Mandatory Referral #MR2016007 – Dorsey Mill Road Bridge over I-270 (FCP Filing Date: 10-30-15)

Completed: 12/03/2015

Figure 4 – Proposed Bridge Typical Section over I-270 (Looking East)

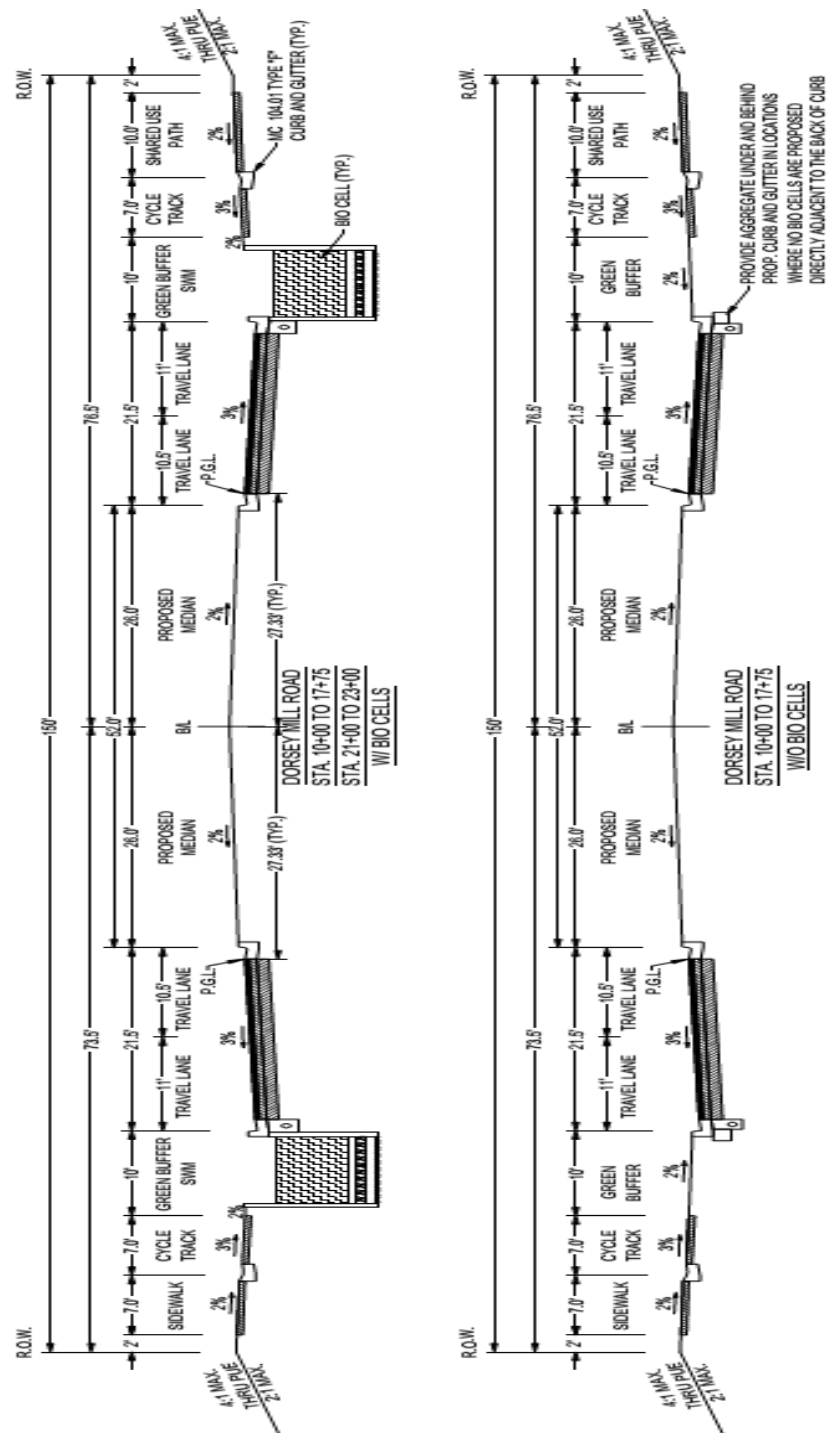
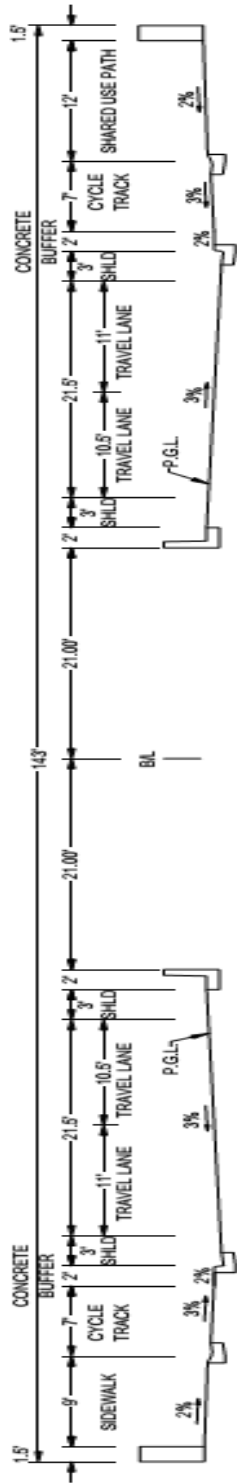
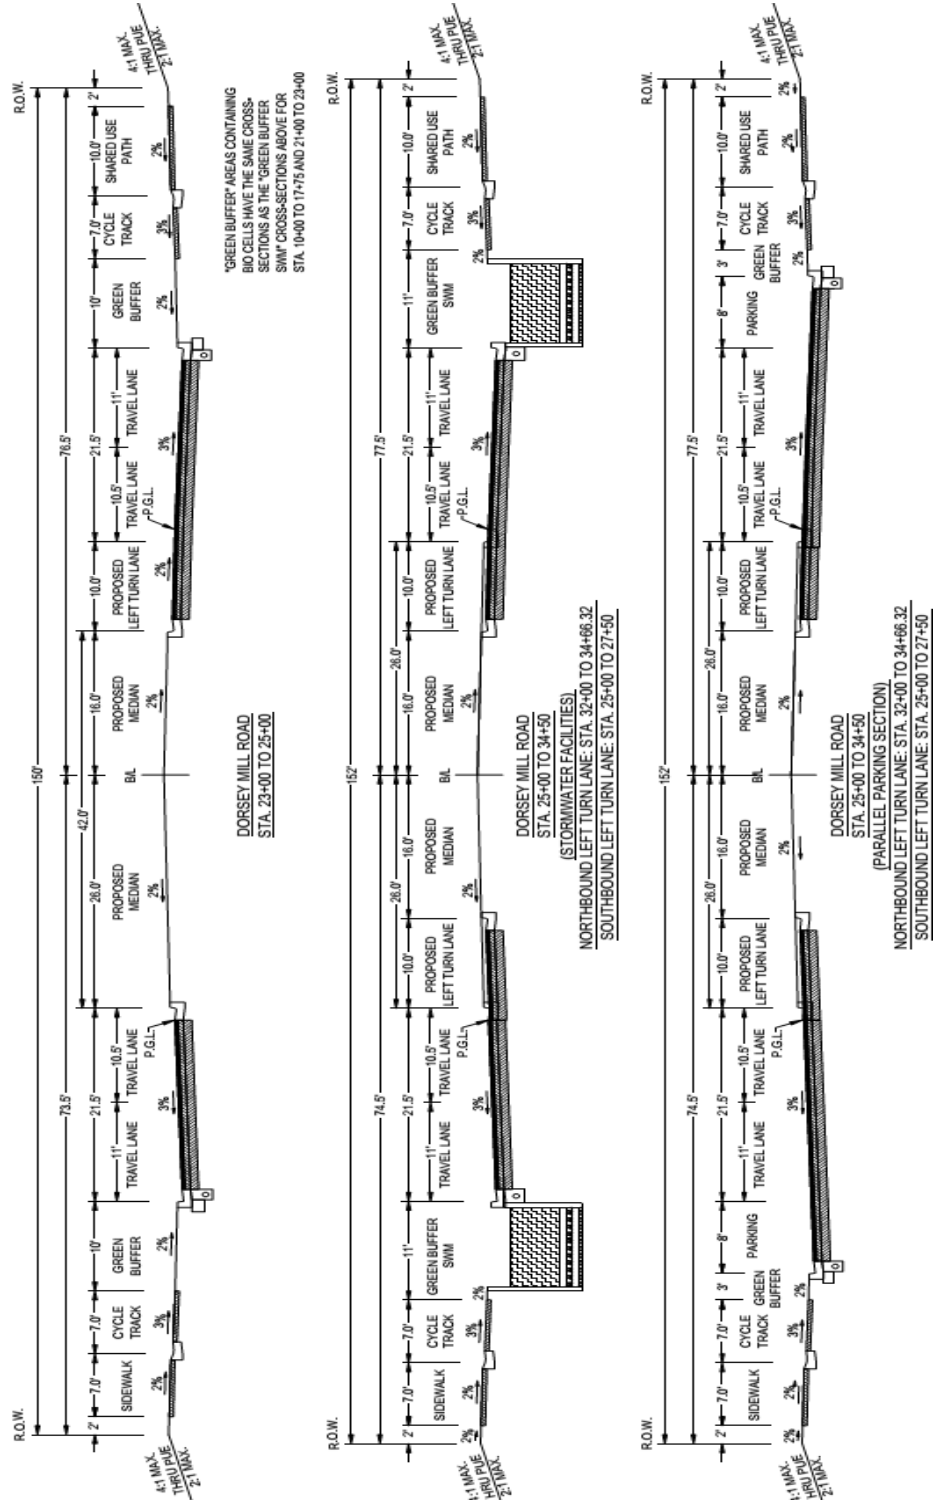
- 3. Work with SHA to obtain their agreement on reducing the shoulder width on the bridge given the importance of using some of that area to increase the width of the buffer on the bridge.**

The proposed typical section is a variation of the County's standard (MC-2005.04) for a four-lane Business District Street but is consistent with the Master Plan that acknowledges the need to also accommodate the Corridor Cities Transitway within the median as well as the other design elements. **Staff is generally very supportive of the typical section as included in the Mandatory Referral Submittal. MCDOT and its design team solicited Staff input early in the process and has been responsive to many staff suggestions.**

Figure 6 – Proposed Dorsey Mill Road west of I-270

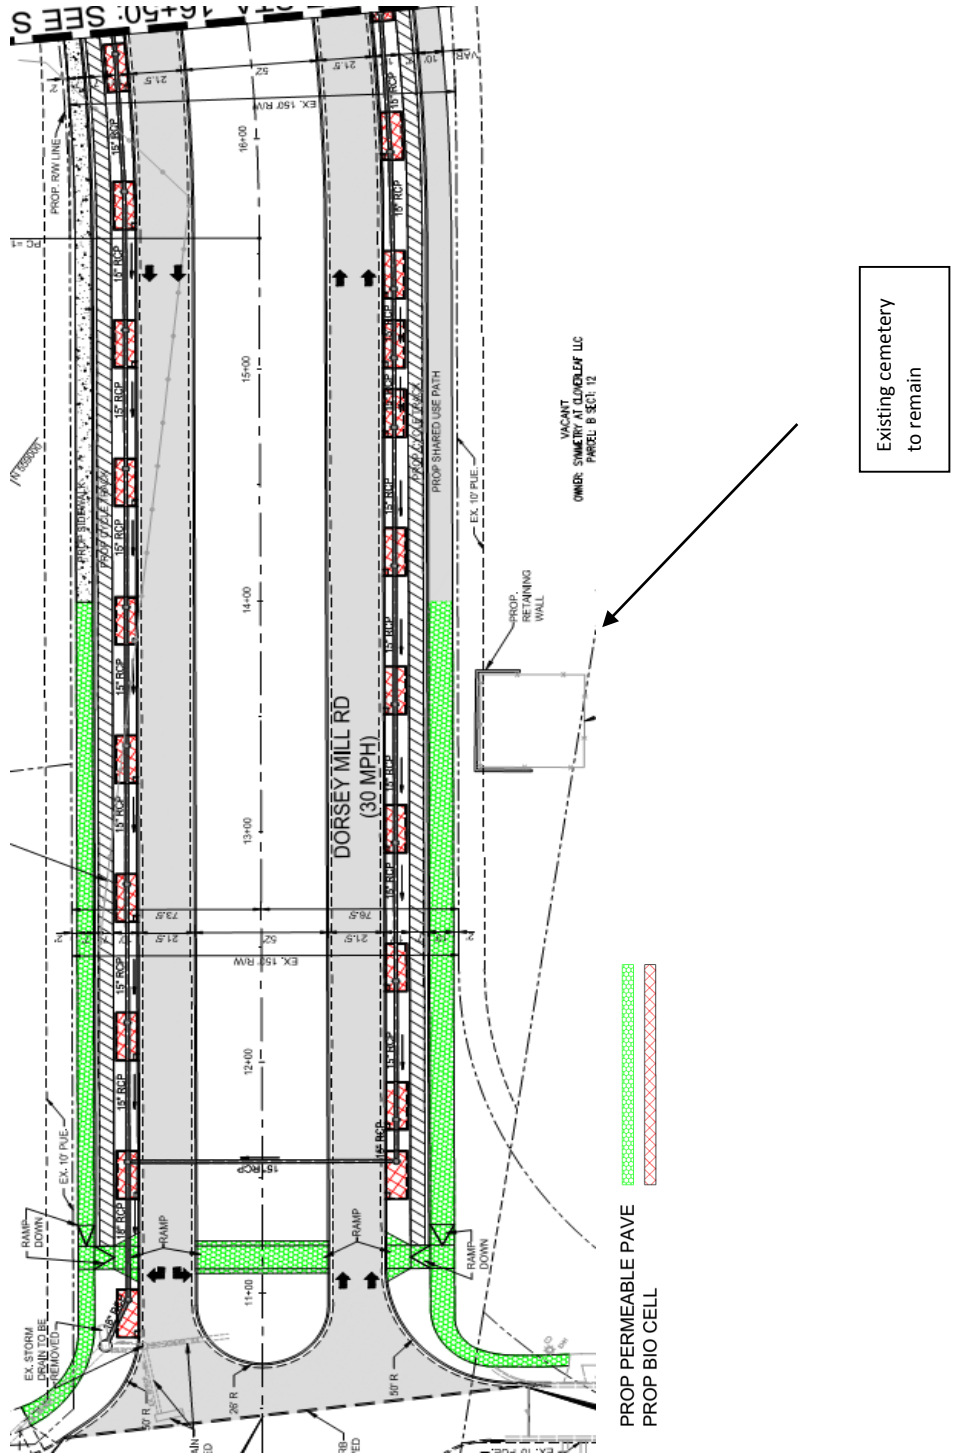
Key additional design features in the submittal included permeable pavement for segments of the shared use path (south side) and sidewalk (north side) and bio-cells within the buffer area for stormwater management.¹ Additional information on the stormwater management plan is provided later in this staff report. Street trees will be spaced approximately every 30 feet and street lights approximately every 150 feet.

The T. Waters Farm family cemetery contains the grave sites of five members of the Waters family and will be protected by a retaining wall as the cemetery is up to five feet above the shared use path. The cemetery is under the care and protection of the Germantown Historical Society. **The Applicant should solicit input from the Society in advance of completing Final Design and initiating project construction.**

¹ MCDOT has since modified the plans to include permeable pavement for all of the sidewalk. Permeable pavement is not planned for the shared use path. The modifications were made in response to a Department of Permitting Services comment received after the Mandatory Referral submittal.

Figure 8 – Proposed Dorsey Mill Road Bridge Section over I-270

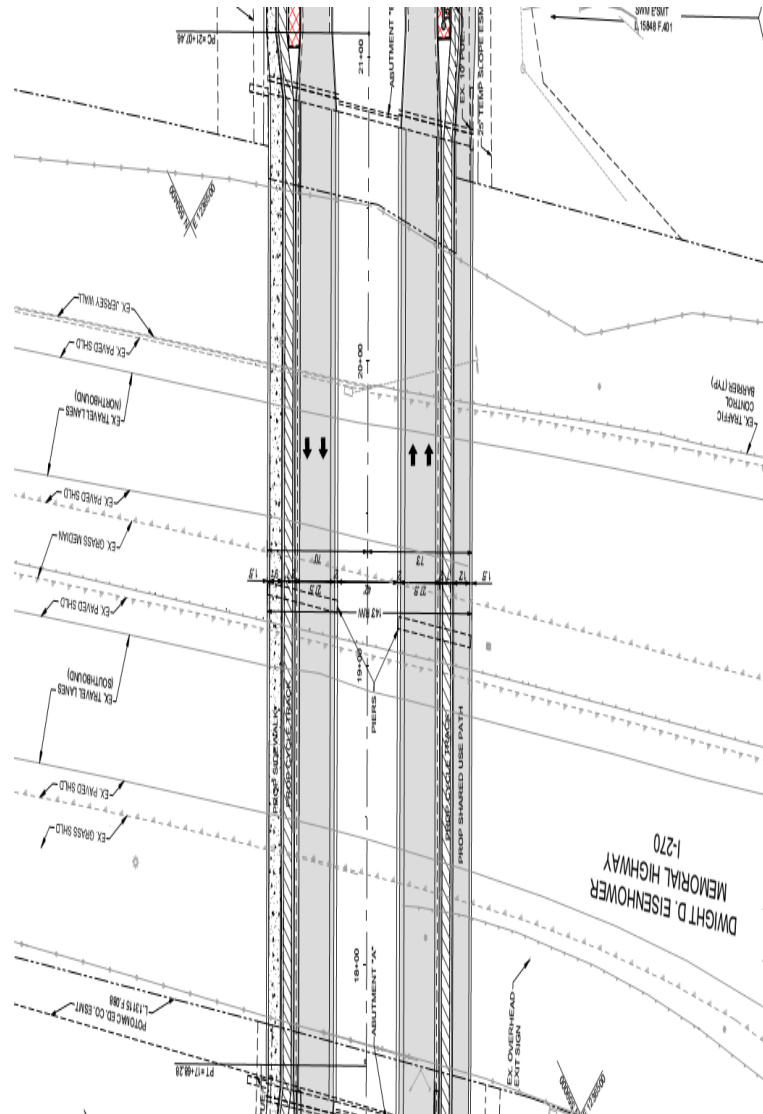
Staff also noted in April the following with respect to the width of the shoulders on the bridge:

“Consider reducing the three-foot width of the shoulders next to the parapets to one foot; eliminating the outside shoulders; and reducing the distance between the sidewalk/shared use path and the right-of-way line to two feet. This space could be used to increase the width of buffer between the travel lanes and the cycle track and/or to provide space for planter boxes on the bridge, either between the cycle track and roadway or on the outsides of the bridge, similar to the 23rd Street Bridge over E Street NW in the District, with the landscaping helping knit the two sides of Germantown together.”

Staff recommends that SHA weigh in specifically as well on the issue of the shoulder width given the importance of increasing the width of the buffer on the bridge if at all possible.

The ownership of the bridge might be transferred to SHA in the future if needed. The shoulder on the bridge must be at least 3 feet to meet the requirements of the 2011 AASHTO (Green Book), A Policy of Geometric Design on Highways and Streets."

Figure 10 – Protected Intersection Design

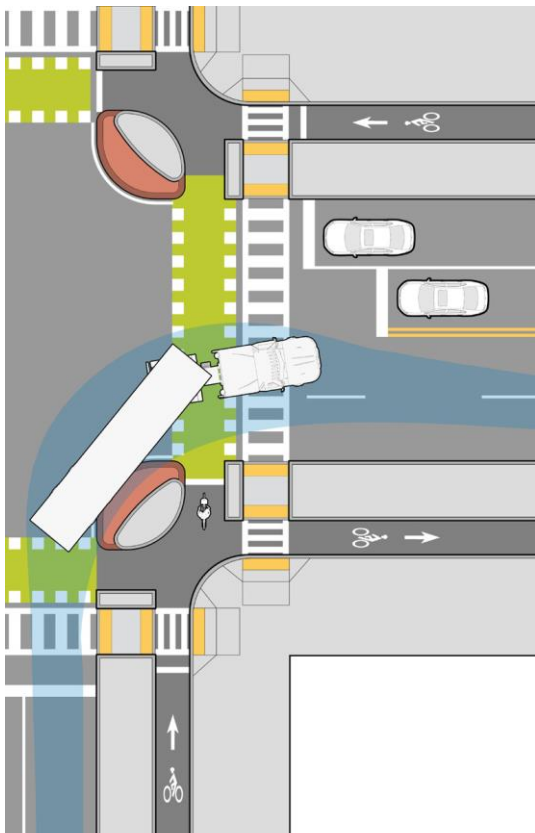
Modify the design of the intersections with Century Blvd and Observation Drive to reflect the “protected intersection” concept. Because the benefits of separated bike lanes (aka cycle tracks) end at the intersection, “protected intersections” have emerged as a preferred approach to intersection design to enhance safety for pedestrians and bicyclists. The Massachusetts Department of Transportation (MassDOT) recently released guidance on separated bike lane design recommends protected intersections as the default intersection design where separated intersections exist or are planned. A typical protected intersection design is shown below in Figure 10.

Figure 11 – Transition from Separate Bike Lane to Shared Travel Lane

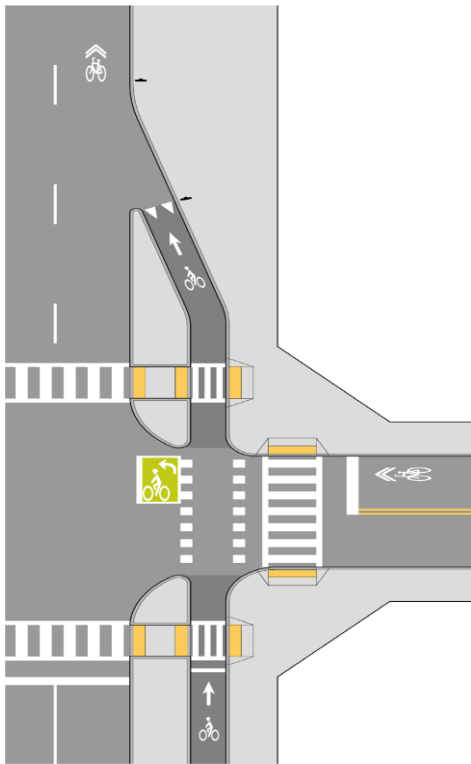
Where separate bike lanes are not planned (Observation Drive) or planned but not implemented (Century Blvd), the “protected intersection” should transition to a shared lane. An example transition concept is shown below:
